DOE/RW-0070  
Volume 3 of 3

# Environmental Assessment

*Reference Repository Location,  
Hanford Site, Washington*

COMMENT-RESPONSE DOCUMENT

Figure C.5-6. Hydraulic head potential in the Umtanum flow top of the Grande Ronde Basalt.

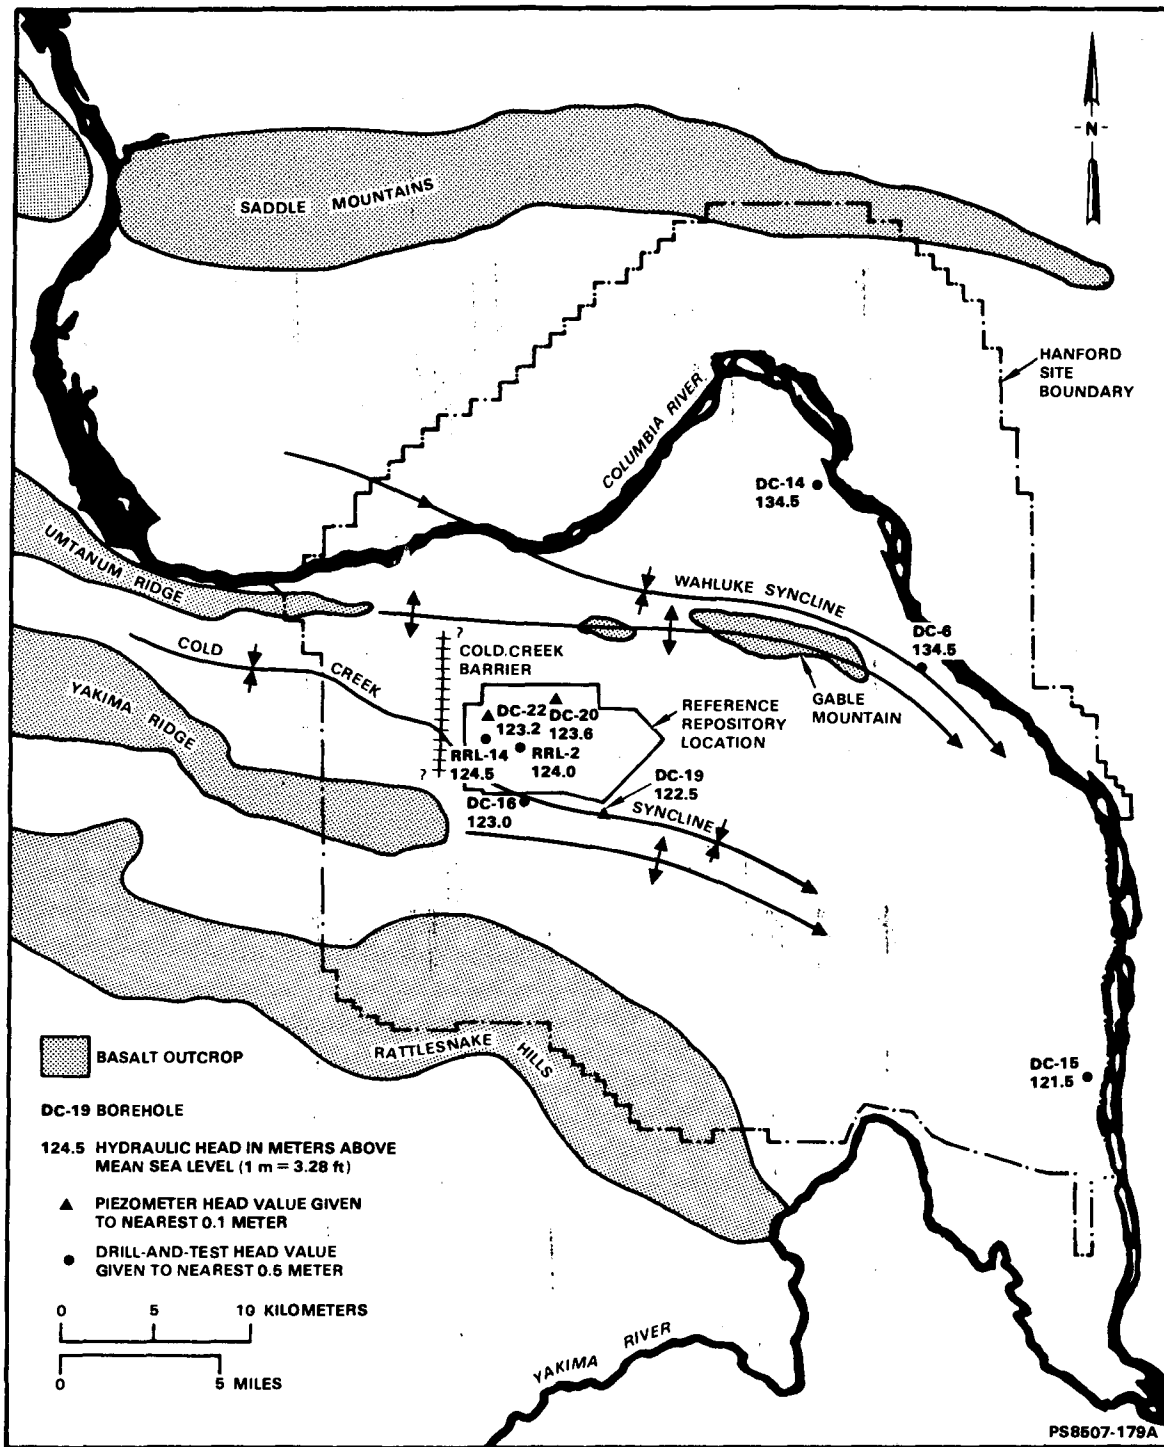
In general, head data indicate flow is from the north side of the Cold Creek syncline to the south side and from northwest to southeast along the synclinal axis. As shown, the axis of the Cold Creek syncline lies close to the Yakima Ridge anticlinal axis. Large head values west of the upper Cold Creek flow impediment (Cold Creek barrier) reflect the resistance to southeasterly flow provided by the impediment. Thus, contrary to the commenter's statements, head data from the drill-and-test program combined with that from boreholes DC-19, DC-20, and DC-22 for the major flow tops do provide a reasonable, general areal pattern of ground-water flow in the Cold Creek syncline. Head data gathered during the drill-and-test program do not present a confusing picture with regard to movement of water as long as one uses values that were well equilibrated.

Figure C.5-7. Sodium and chloride concentrations for the Hanford Site and Columbia Plateau region. Data for the Hanford Site were collected by the Basalt Waste Isolation Project, and data for the Columbia Plateau region were collected by the U.S. Geological Survey WATSTOR data base.

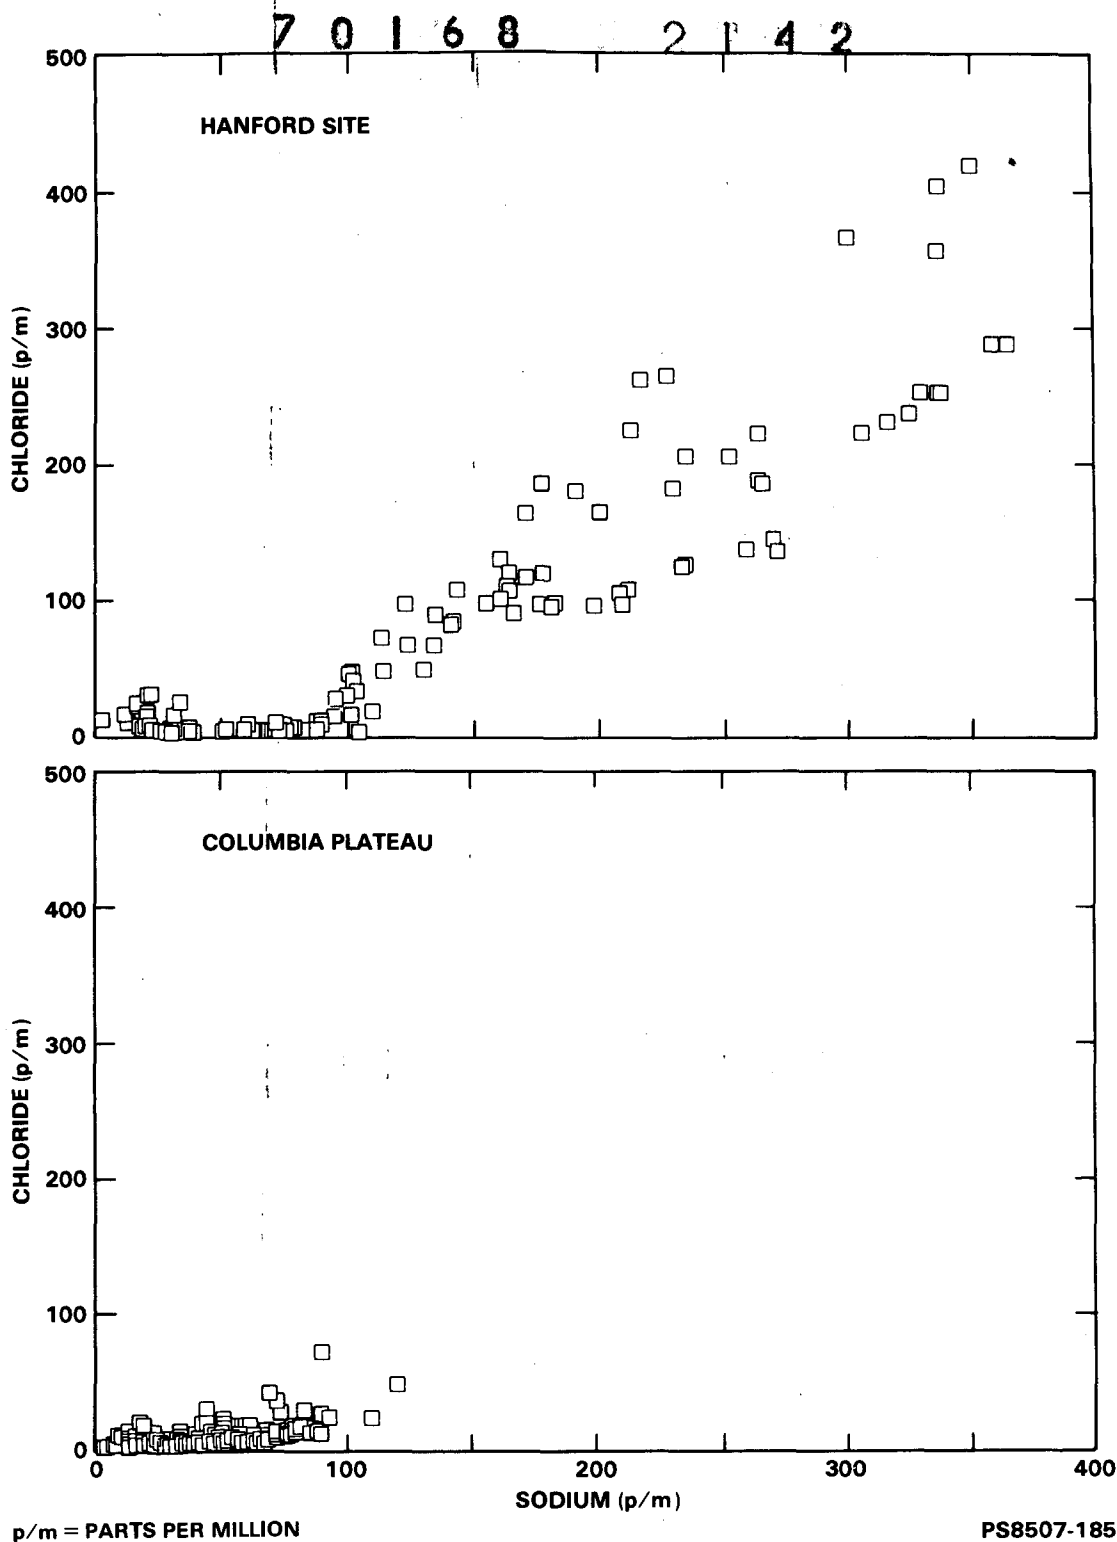
Several comments were received concerning ground-water quality as related to the second potentially adverse condition under geohydrology (DOE, 1984a; 960.4-2-1(c)(2) (see Subsection 6.3.1.1.9 of the Draft Environmental Assessment) and the ground-water chemistry summary as given in Table 3-6. According to some reviewers, the quality of ground waters along likely flow paths between a repository and accessible environment does not preclude use of these ground waters for agriculture or for some future purpose. Two commenters recommended that specific data be presented and compared with various water-quality standards, and questioned the source of fluoride in the water. A comparison was requested between the deep water quality beneath the Hanford Site and that from other areas of the Columbia Plateau.

Throughout the entire Columbia Plateau, ground water used for irrigation is of distinctly lower salinity than that found in the Grande Ronde and lower Wanapum Basalts in the vicinity of the reference repository location. This is true even of Wanapum and Grande Ronde Basalt ground water in the upper Cold Creek syncline, west of the hydrologic and geochemical anomaly occurring along the Cold Creek barrier (see Section 3.3.2 of the Draft Environmental Assessment). Sodium and chloride concentrations for waters from these two areas are plotted in Figure C.5-7. Ground water in the Columbia Plateau, excluding the Hanford Site, is characterized by low chloride (generally 10 parts per million or less) and sodium concentrations (ranging from near zero to slightly greater than 100 parts per million) (U.S. Geological Survey WATSTOR data base). The shallow Saddle Mountains Basalt ground water at the Hanford Site has similar characteristics. Water with these characteristics is found at all depths in the region for which data are available.

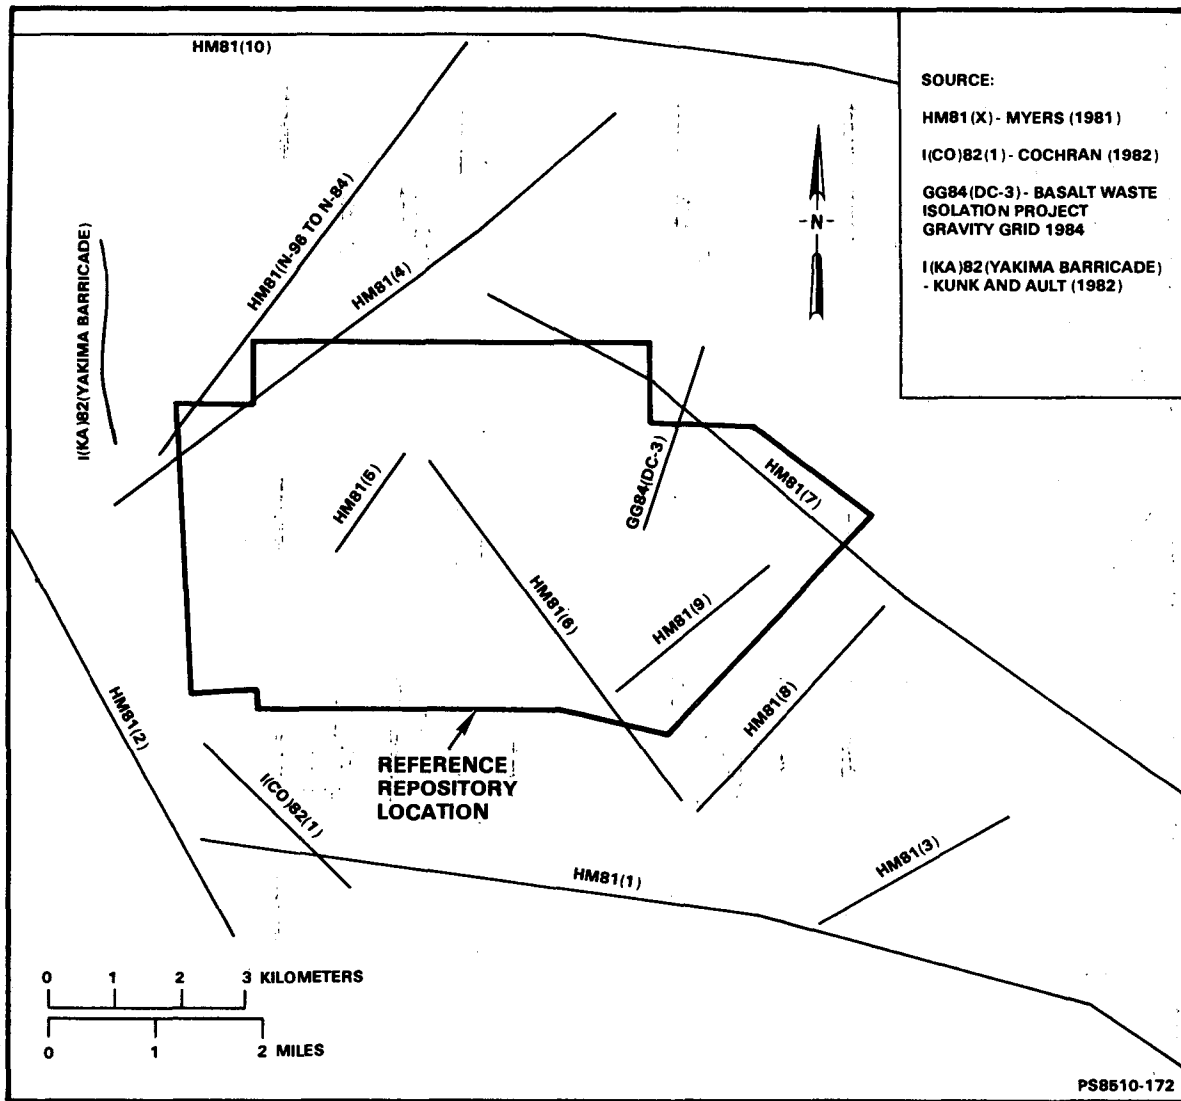
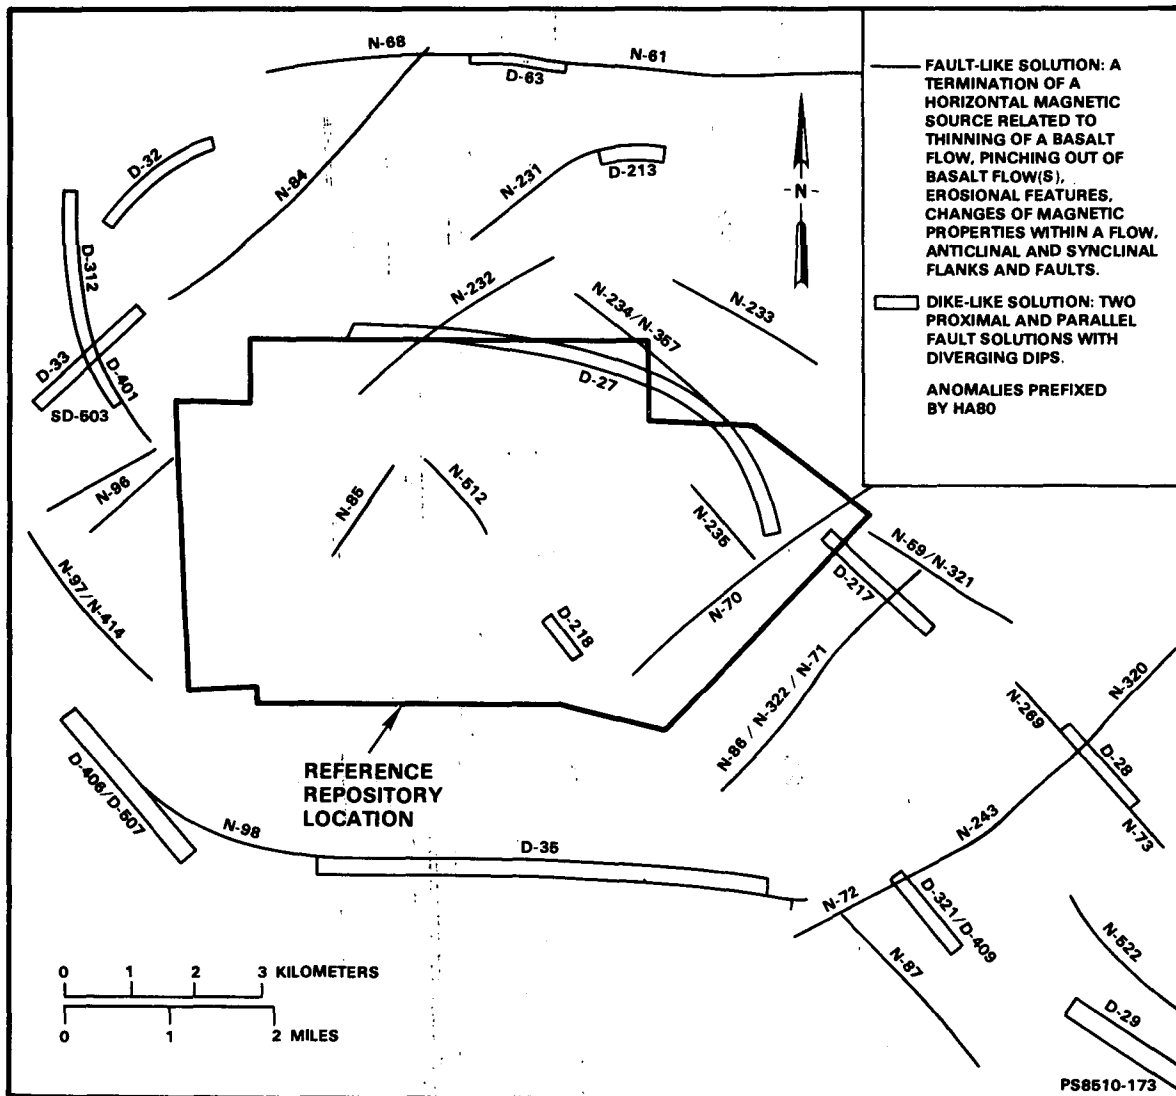
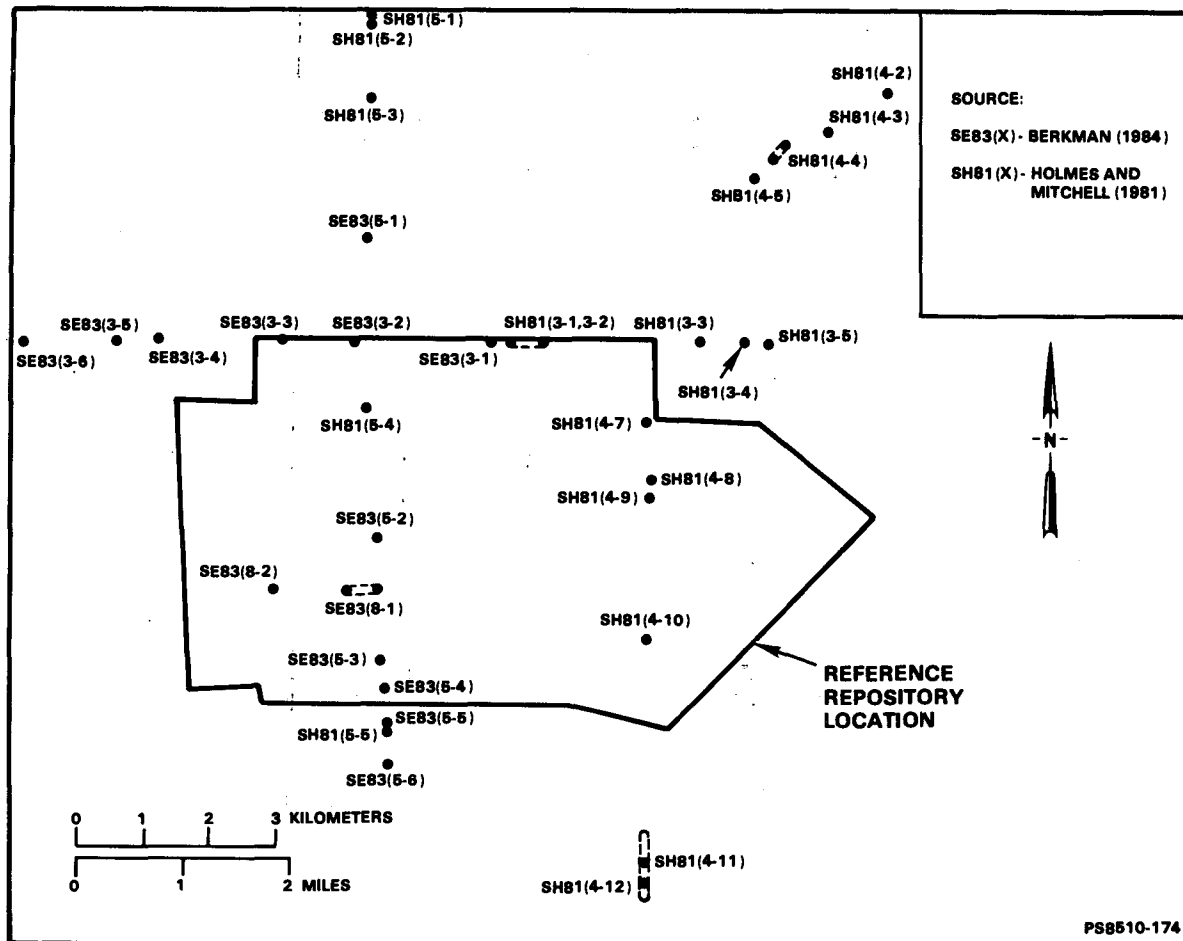
Many commenters suggested that geophysical anomalies were not used in establishing the geologic conditions in Chapters 2 and 3 of the Draft Environmental Assessment.

The more significant structural and topographic features such as the Gable Mountain-Gable Butte anticline, the buried extension of Yakima Ridge, and the eastward terminus of Yakima Ridge (see Fig. 3-20) are clearly depicted from the geophysical data sets. In and more immediate to the reference repository location the geophysical character is much more subdued and does not suggest any throughgoing faults or folds in the reference repository location. Because of the subtle nature of the data, geophysical anomalies that have been identified cannot be reliably or clearly delineated as can the structural and topographic features bounding the reference repository location; this suggests that features, if present, are relatively small. Figures C.5-9 through C.5-11 show the geophysical anomalies that have been identified in the proximity of the reference repository location. Table C.5-6 summarizes the status of these anomalies.
